Bulletin No: B414R1211-0
Release Date: August 18, 1999
Effective Date: August 18, 1999
Supersedes: N/A
Completion Date: September 18, 1999
Page: 1 of 4

SERVICE BULLETIN

Ride Name: INVERTER Affected Serial Nos.: All

Abstract of Issue:
Inspection, Replacement and Operation of Hydraulic Lock Cylinders

*Hydraulic lock cylinder
for primary restraint bar
(lap bar)*

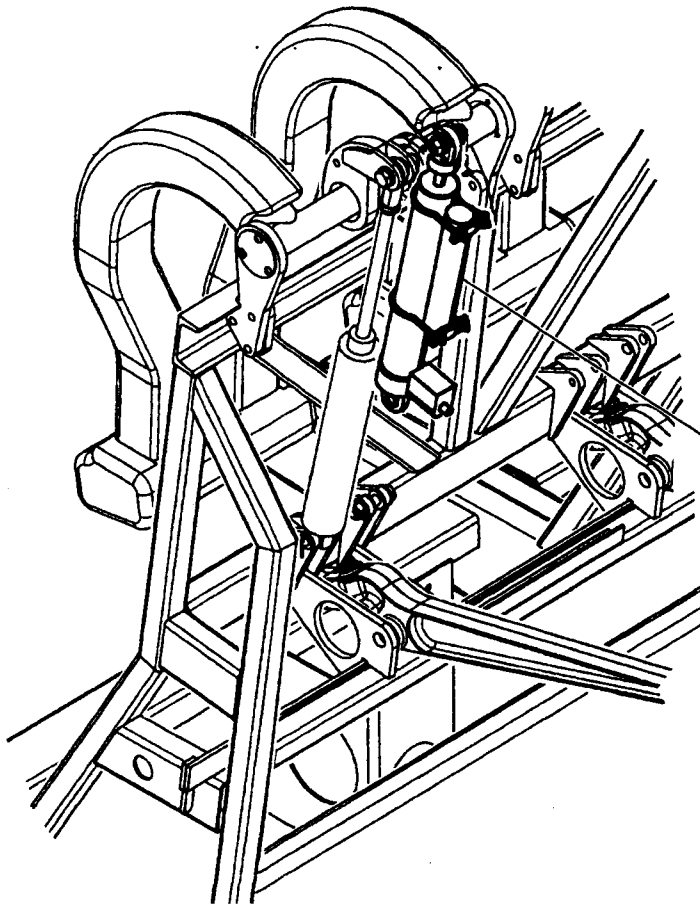
Inspect the hydraulic lock cylinders for all seats (24 total). Identify the cylinders based on the distinguishing characteristics detailed on the next page.
